Subject: Bid Package #1
Borel Middle School HVAC Replcmt-DSA 01-119557
College Park Elementary School HVAC Replcmt-DSA 01 119530
Meadow Heights Elementary School HVAC Replcmt DSA 01-119554
North Shoreview Montessori School HVAC Replcmt DSA 01-119526
San Mateo - Foster City School District

ADDENDUM NO. 1

Subject: Borel Middle School HVAC Replacement
San Mateo - Foster City School District
Aedis Project No. 2021005
DSA Application #01-119557

ADDENDUM NO. 1

SHEET # AD-1
E1.1

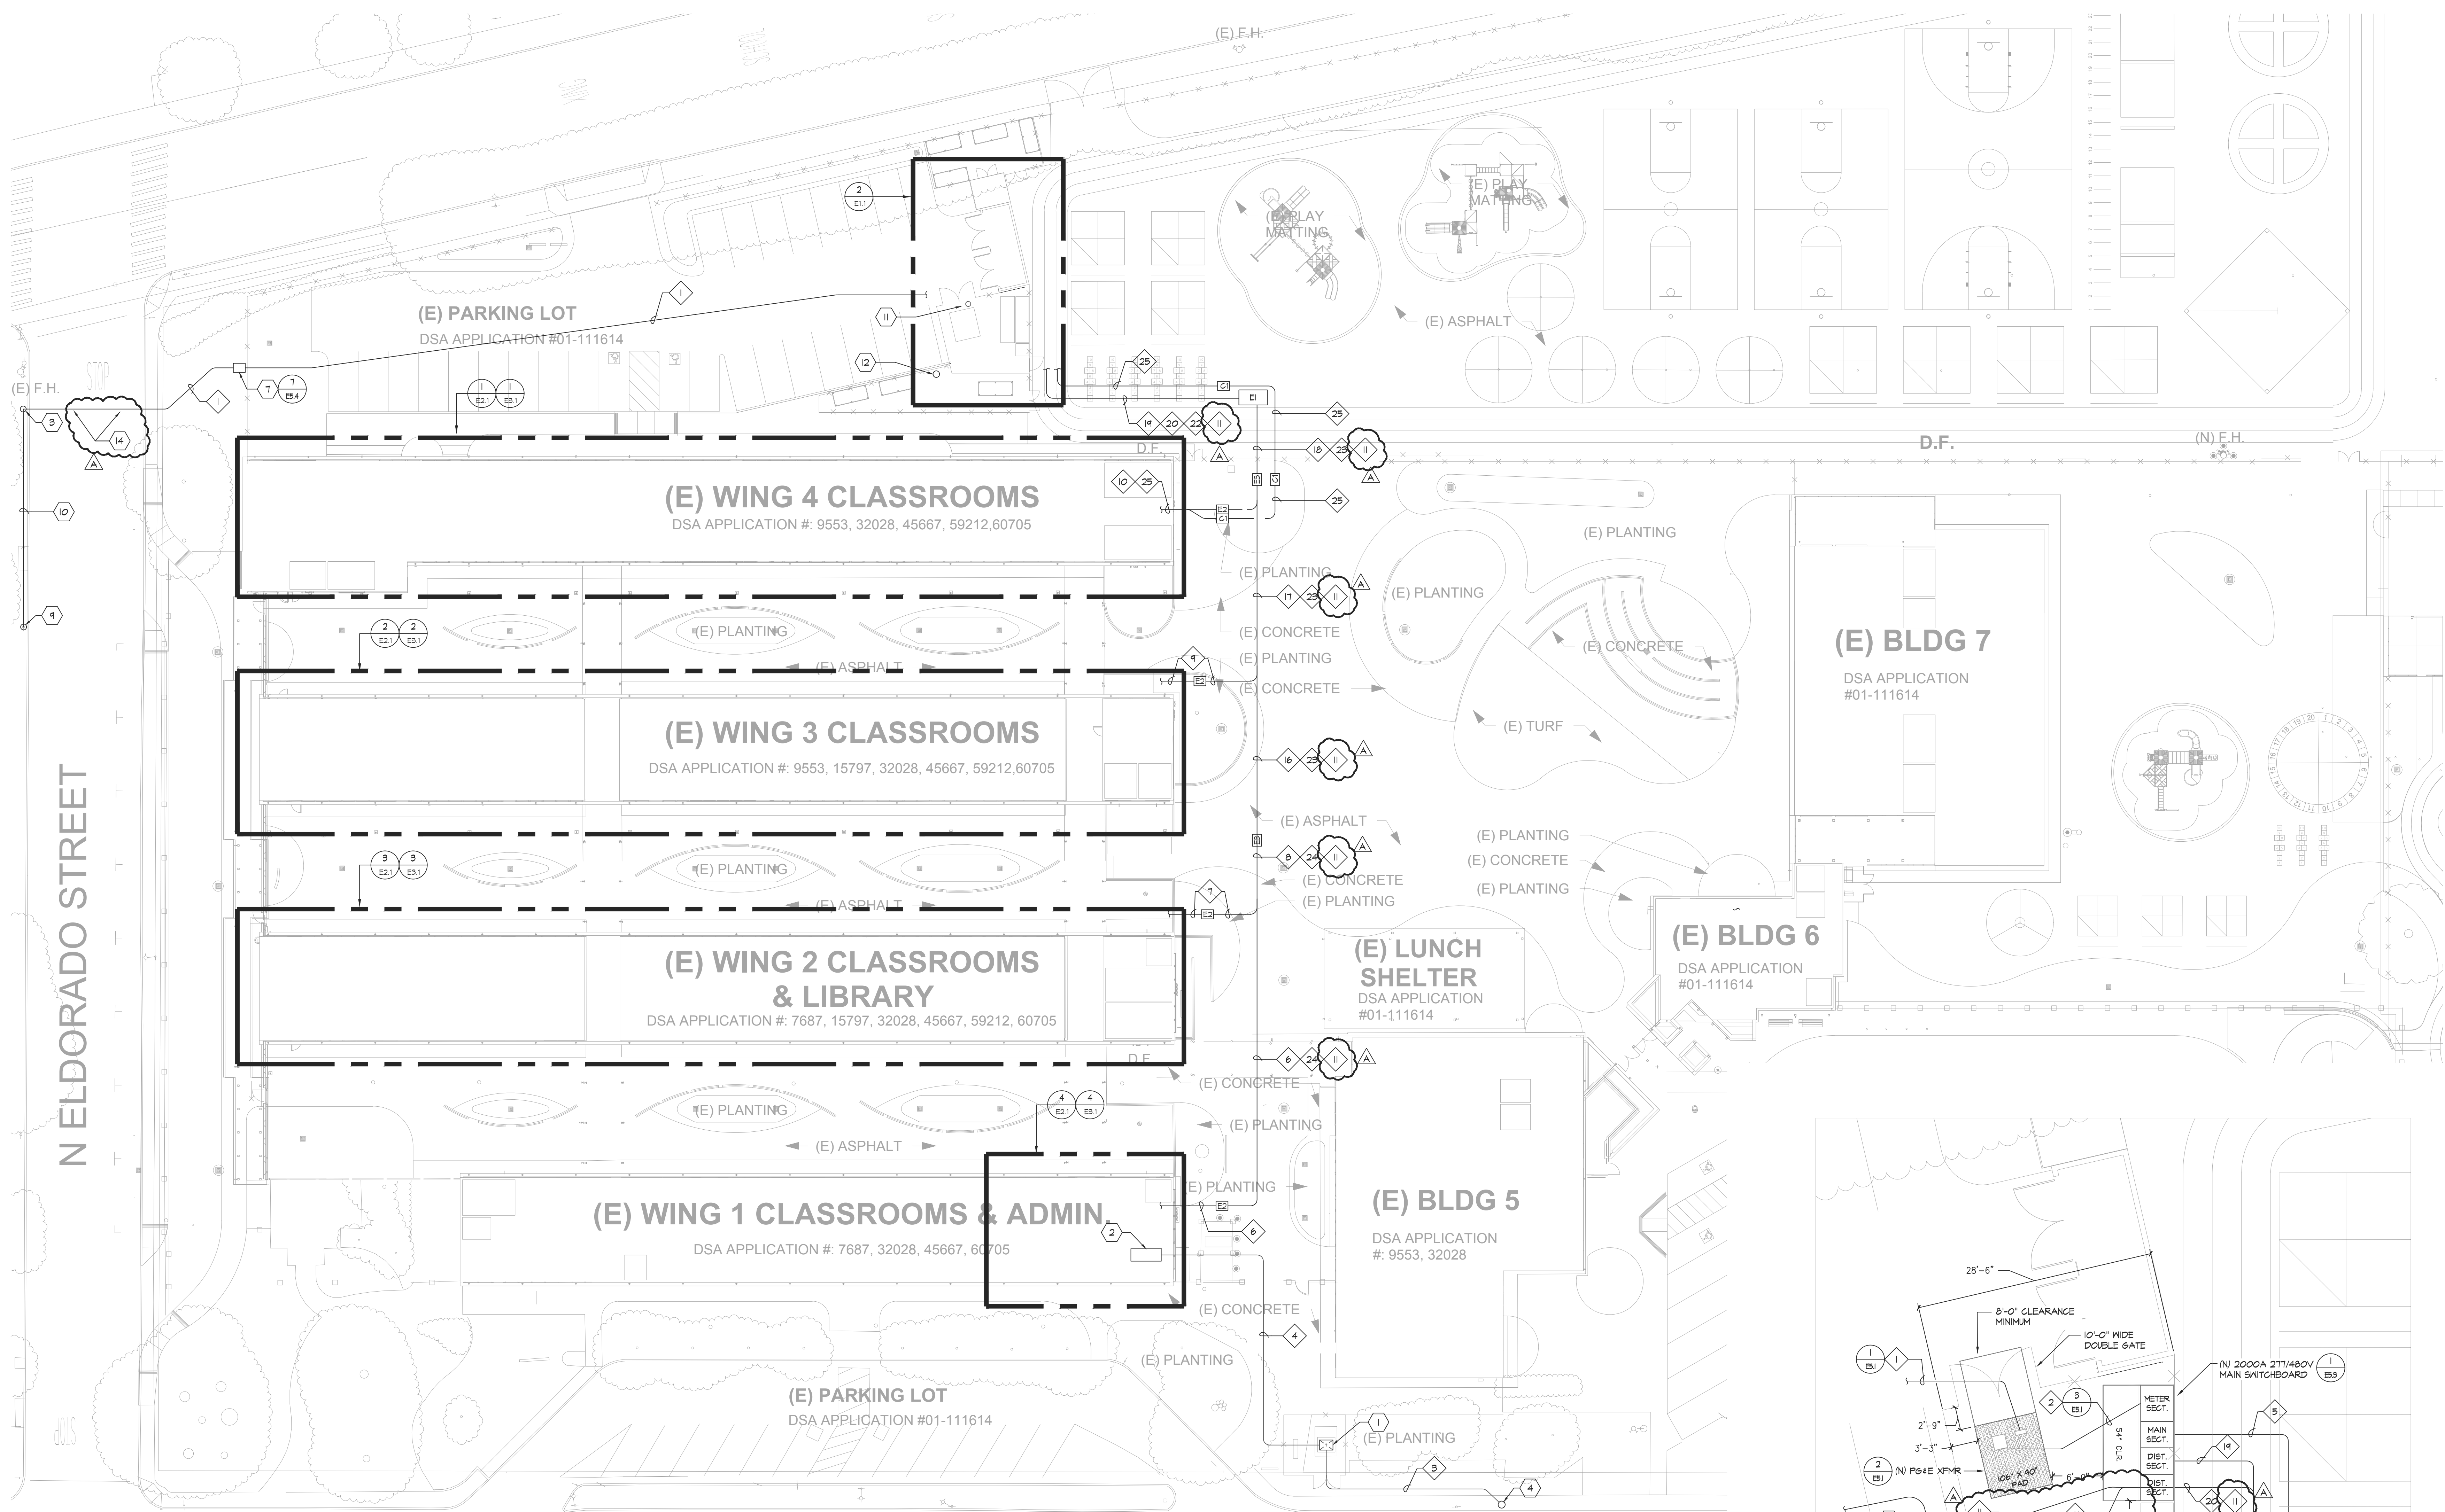
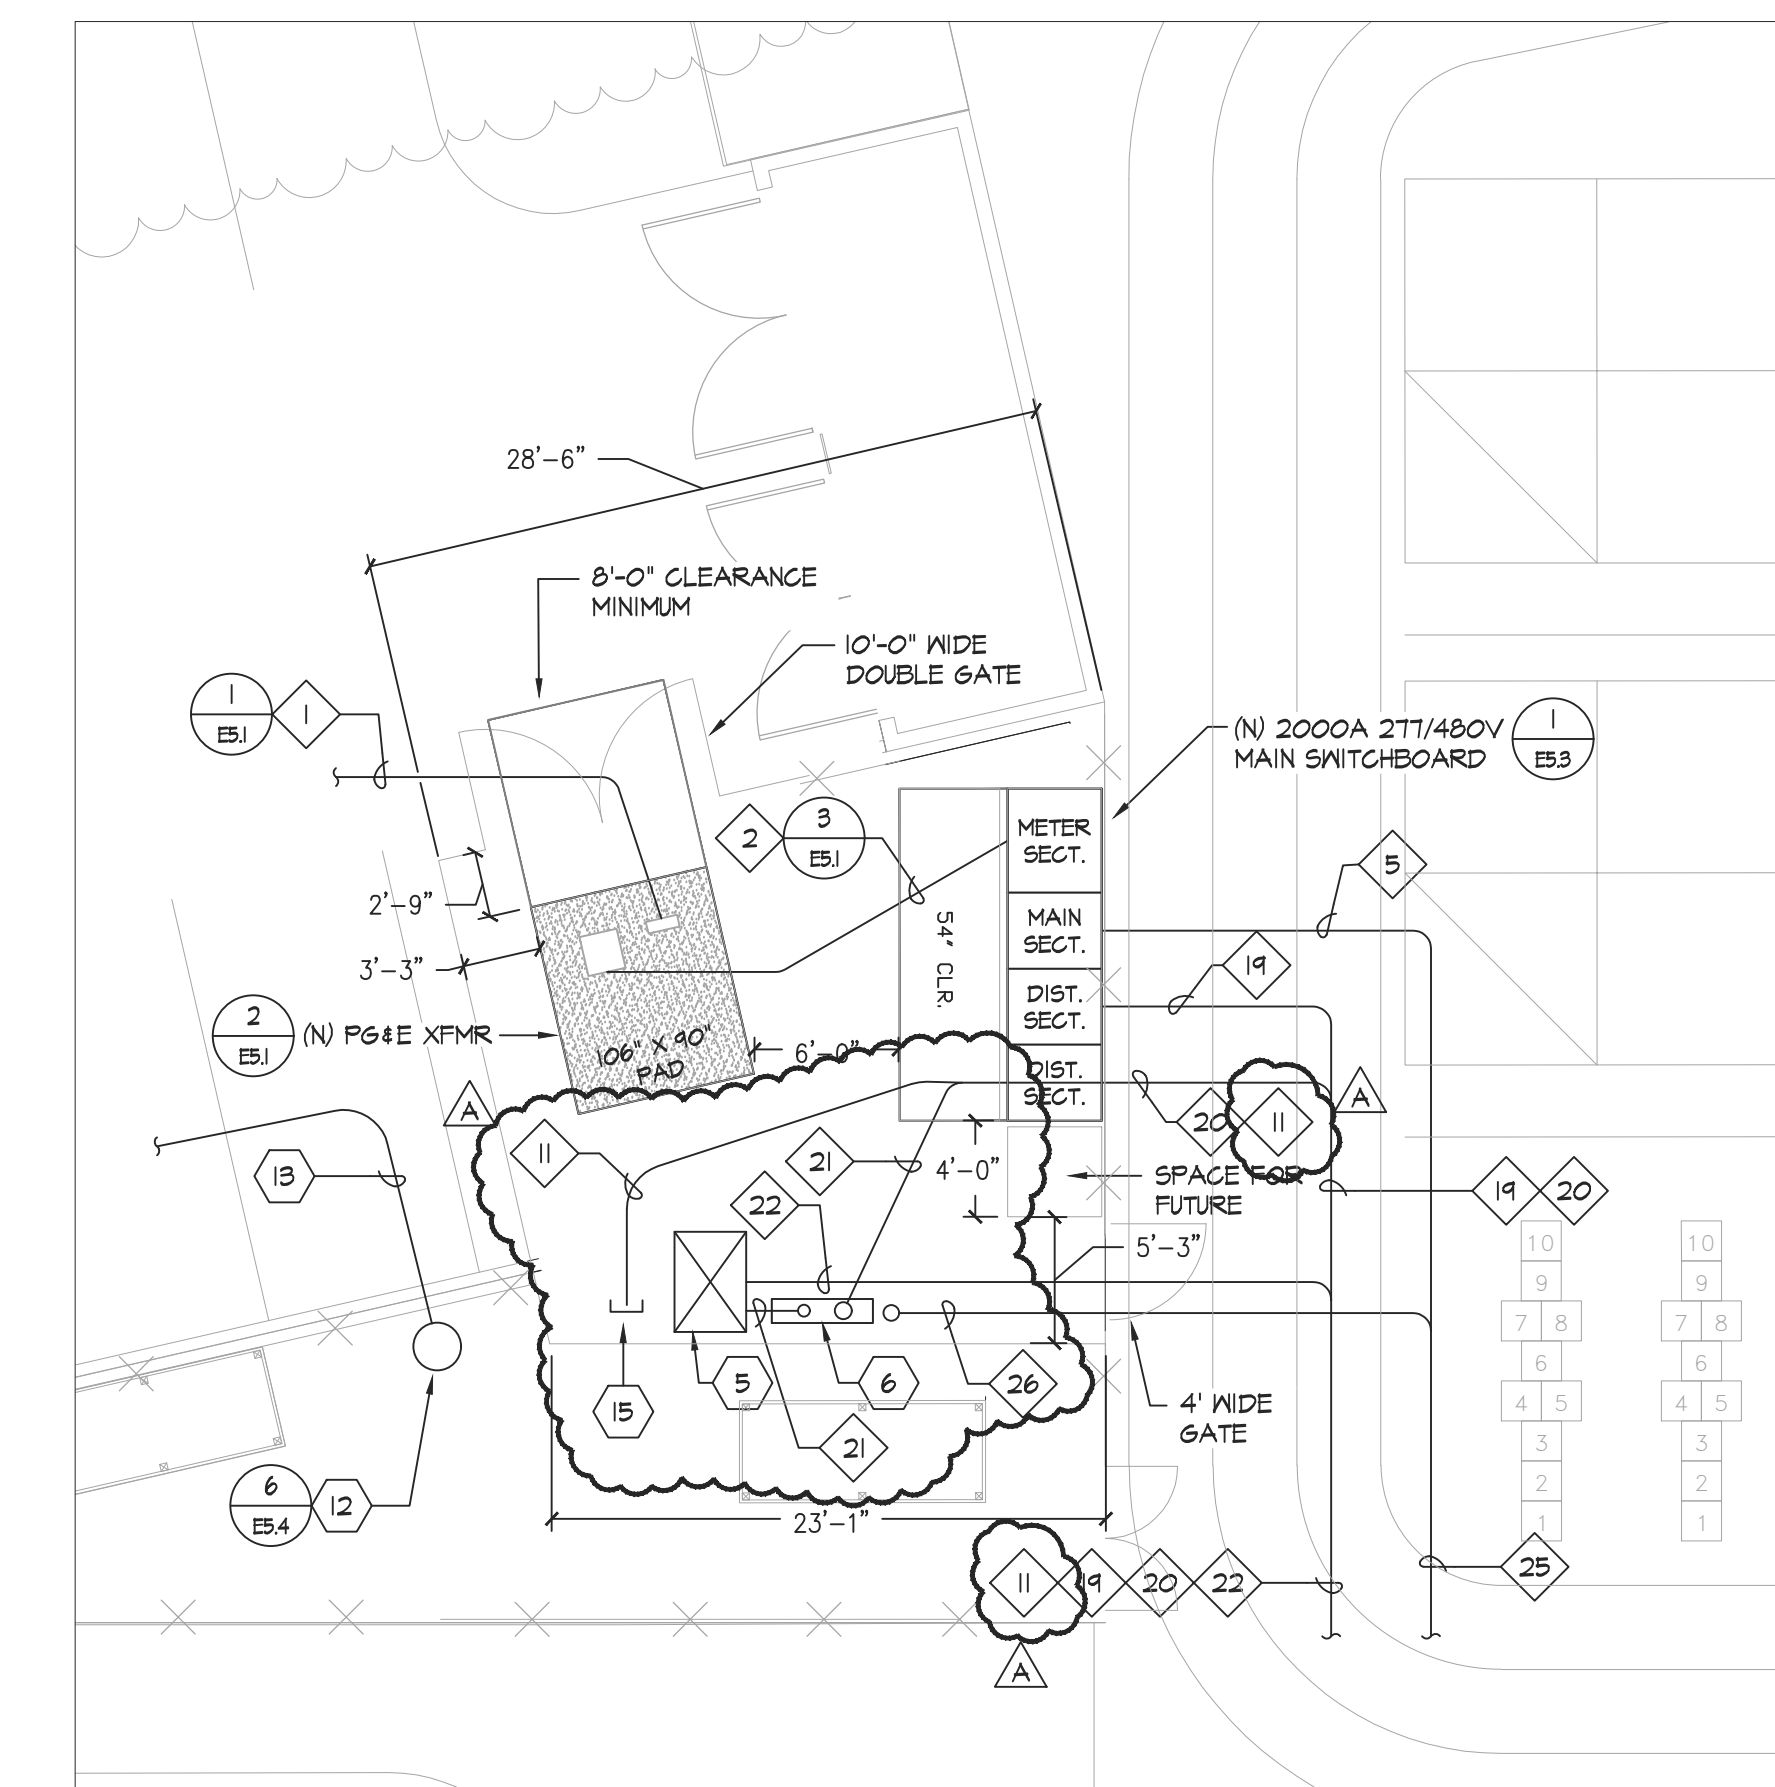
Revise: Conduit Schedule tag #11 per AD1-E1.1
Add: Sheet Notes #14, 15 per AD1-E1.1
Add: Underground EV conduit added at 2/E1.1 per AD1-E1.1

DATE **11/24/2021**
JOB # **2021005.01**
SHEET # **AD-1
E3.1**

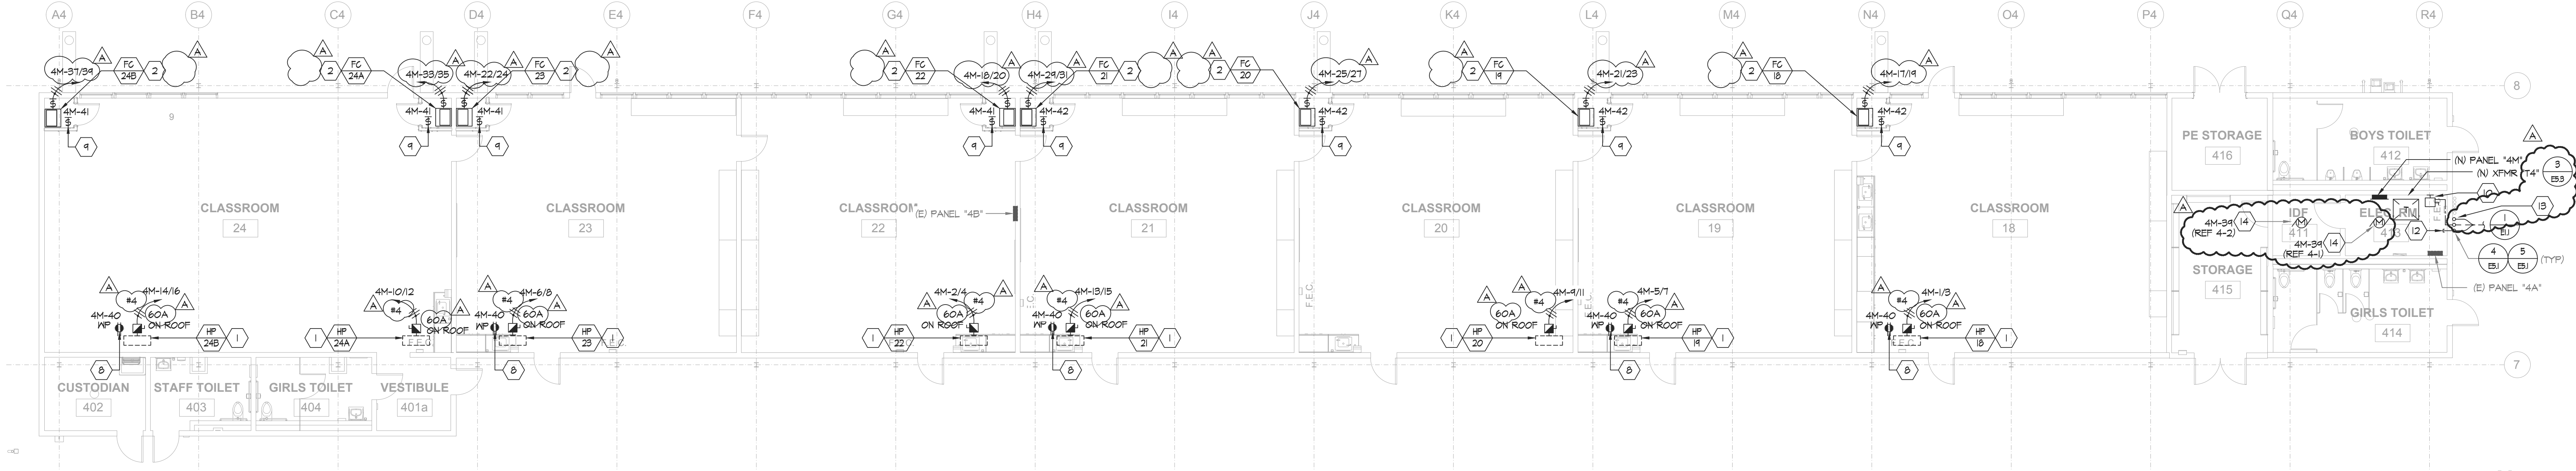
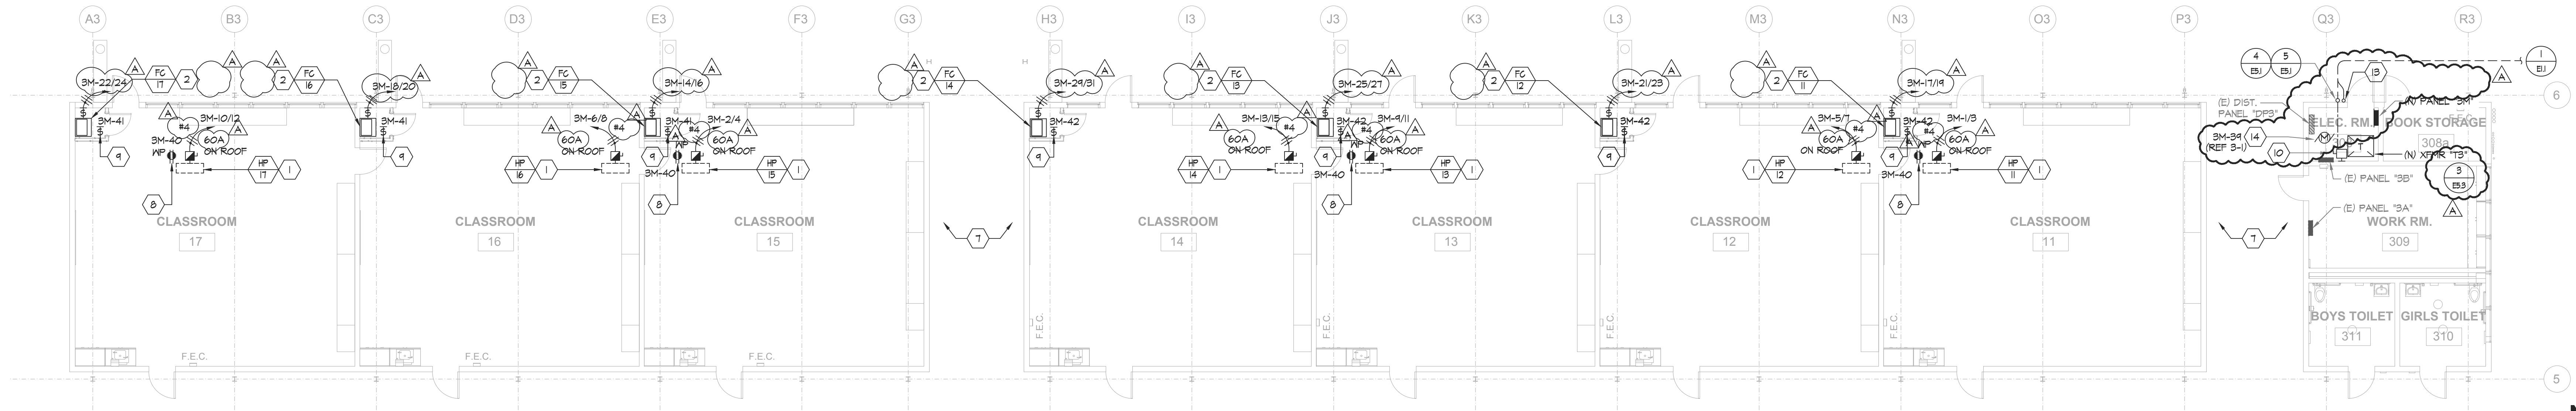
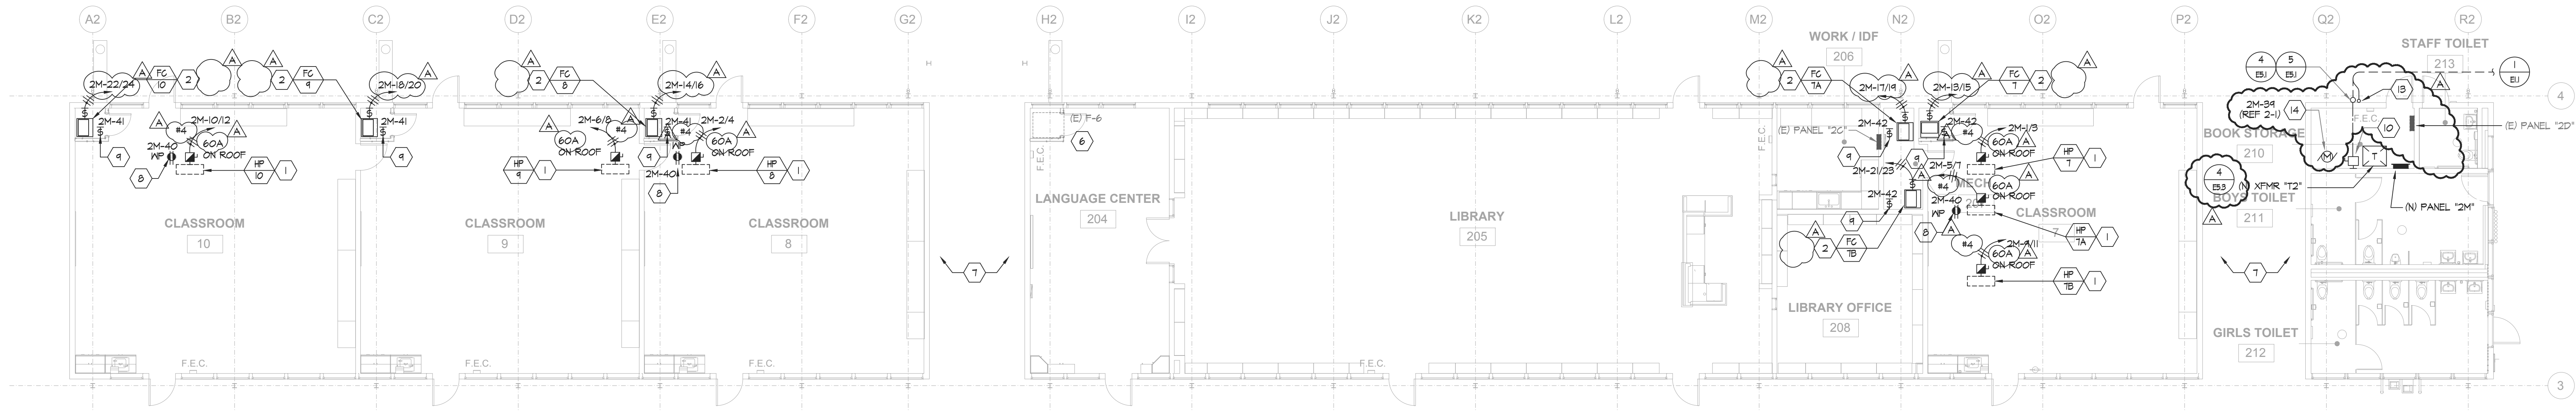
Add: Power for exhaust fan at each wing per AD1-E3.1
Add: Solar Conduit stub ups at each wing per AD1-E3.1
Revise: Electrical plan 1/E3.1, 2/E3.1 & 3/E3.1 per AD1-E3.1
Add: General Note #6 per AD1-E3.1
Revise: Sheet Notes #1, #2 & #4 per AD1-E3.1
Add: Sheet Notes 13 & 14 per AD1-E3.1
